Staff – Exhibit 101
Corrected Testimony of Claire M. Eubanks, P.E.
Surrebuttal
File No. EA-2024-0302

CORRECTED SURREBUTTAL TESTIMONY

AMEREN TRANSMISSION COMPANY OF ILLINOIS

CASE NO. EA-2024-0302

Case No. EA-2024-0302
Schedule CME-s2
Page 6 of 10

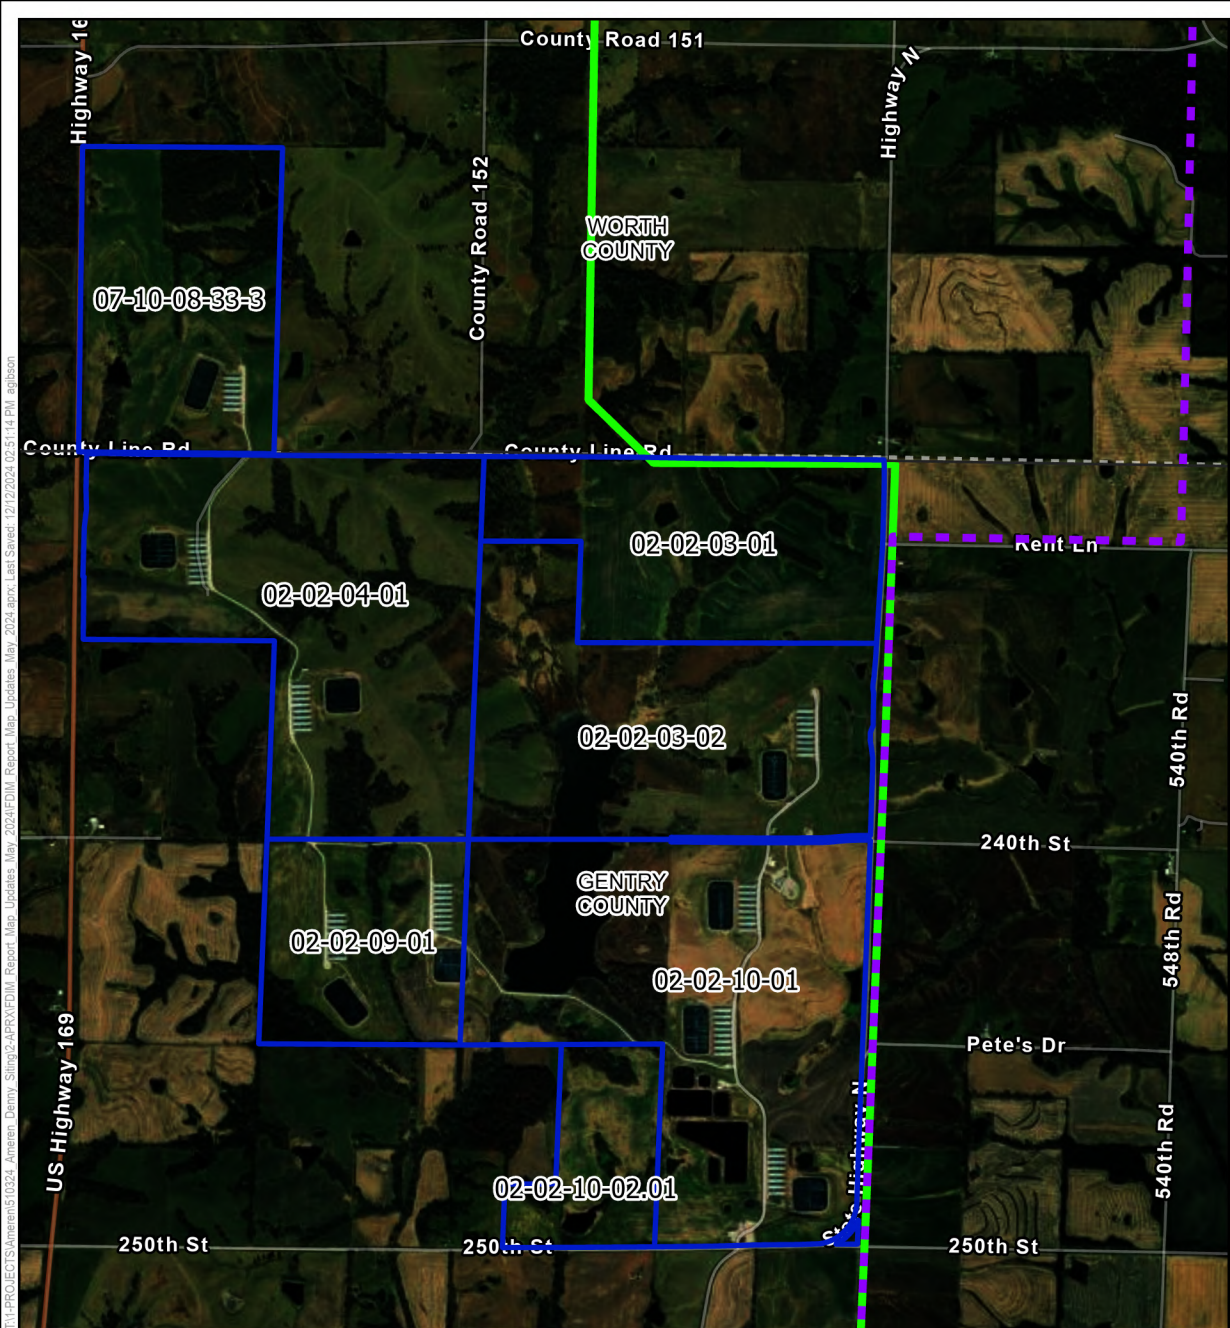
Regarding the hog-farm discussed at page 29 of TRC's FDIM routing study and page 21 of James Nicholas' direct testimony. 1. TRC and James Nicholas indicates the hog farm facility is located southeast of the intersection of Highway N and 230th road. Please confirm that the hog farm is located to the southwest of the intersection of Highway N and 230th road. 2. Please identify all parcels associated with the hog farm facility.

Regarding the hog farm discussed at page 29 of TRC's FDIM routing study. TRC states: "This presented access issues both for construction and ongoing line maintenance, as the facility restricts access due to contamination concerns." Provide all documentation available to ATXI or its consultant that supports the statement that the facility restricts access.

1. The hog farm facility is located to the southwest of the intersection of Highway N and 230th Road.
2. Please see MPSC 12.1 Attach.

ATXI does not have documentation available for this specific facility because it elected to avoid routing FDIM on the hog farm property. However, ATXI is aware of the heavily regulated nature of the animal agricultural industry and facilities engaged in livestock production. Strict measures can be implemented and are typically in place to protect the health and wellness of animals and humans, prevent disease and biological hazards, reduce impacts on quality of water and air, and to ensure the safety of the food supply. Property used for large livestock production facilities, Animal Feeding Operations (AFO) or Concentrated Animal Feeding Operations (CAFO), is likely to require the Company to follow procedures to minimize or reduce the introduction or spread of hazards that could affect the health and wellness of the animals, people, and environment, which would limit Company's ability to safely operate and maintain the line. The Proposed Route for the FDIM Project avoids the risk by avoiding the hog farm.
